Technical Service Bulletin: tsb100503

New Coolant Filter Head Spacer

This Parts Announcement introduces a new coolant filter head spacer for the QSK45 and QSK60 engines, Part Number 4101315, and describes the relocation of the coolant pressure sensor.

Figure 1, New Installation Arrangement

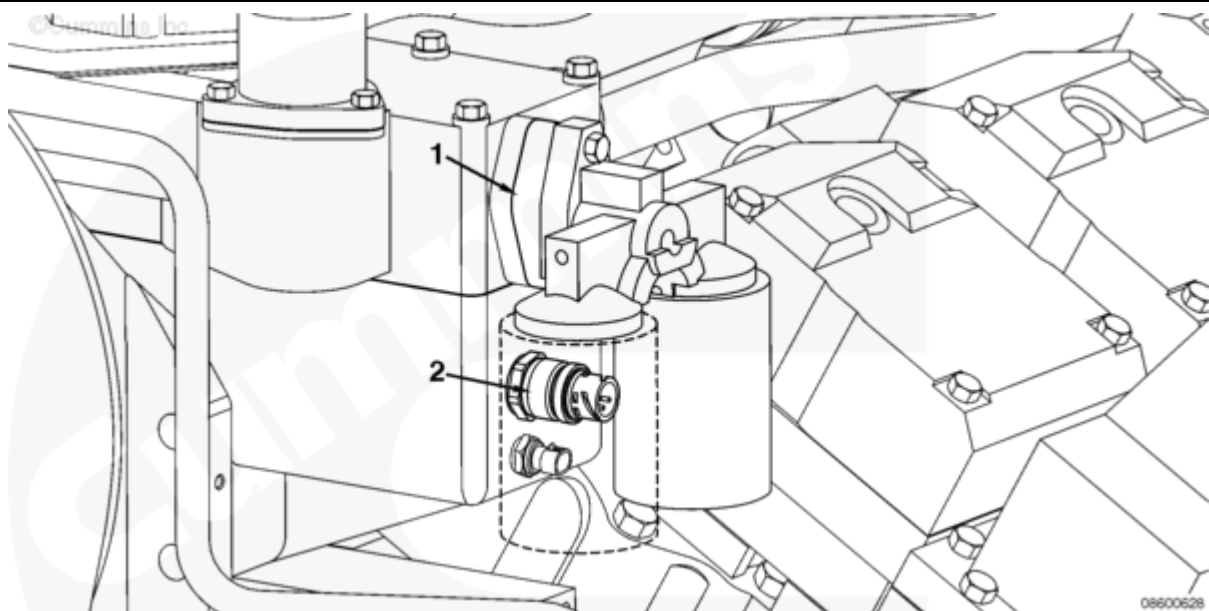
The new spacer, Part Number 4101325 (1), allows for the relocation of the coolant pressure sensor (2) from the coolant rifle at the KIM hot-start port located between the number 1 and number 2 cylinders on the left bank of the engine to the left bank side of the thermostat housing, with the sensor body and extension connector located between the coolant filter canisters.

The relocation of the coolant pressure sensor from the cylinder block jacket to the thermostat housing requires connector sub-harness, Part Number 3635690, and a new version of the calibration software. This configuration is now the standard on Industrial engines made on or after February 23, 2004, with engine serial number first 33155959. The relevant versions of the software are published on the calibration CD dated April, 2004, and later.

The relocation of the coolant pressure sensor from the cylinder block jacket to the thermostat housing requires **only** the new spacer, Part Number 4101325, as the Generator harness and software were designed for the sensor relocation. This configuration is now the standard on QSK45 Generator engines made on or after December 2002, with engine serial number first 33153135 and on QSK60 Generator engines made on or after April 7, 2003, with engine serial number first 33153788.
